Hathaway's Pond

ADA Transition Plan

October 2021

Institute for Human Centered Design

Figure 1:

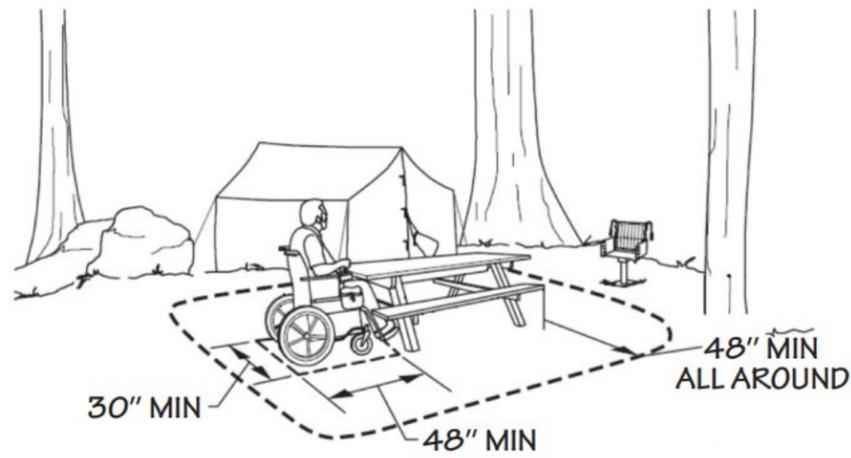
- Recommend providing benches, some with arms and some with backs, near the toilet rooms and in shady areas.
- Recommend providing one bench with a back and one bench with arms in each viewing area.
- Recommend providing a 48" wide min. stable and firm surface such as stone dust under and around at least one accessible picnic table in each distinct picnic area. See Figure 1 below:

Figure 2:

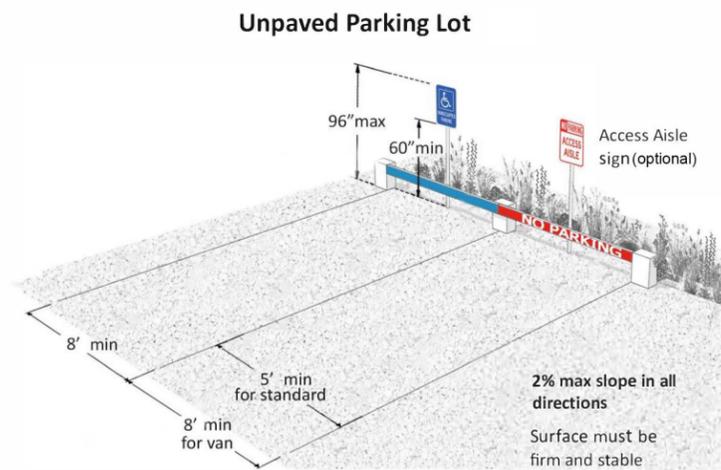
- See Figure 2 illustrating one way to mark accessible parking spaces at unpaved parking lots.
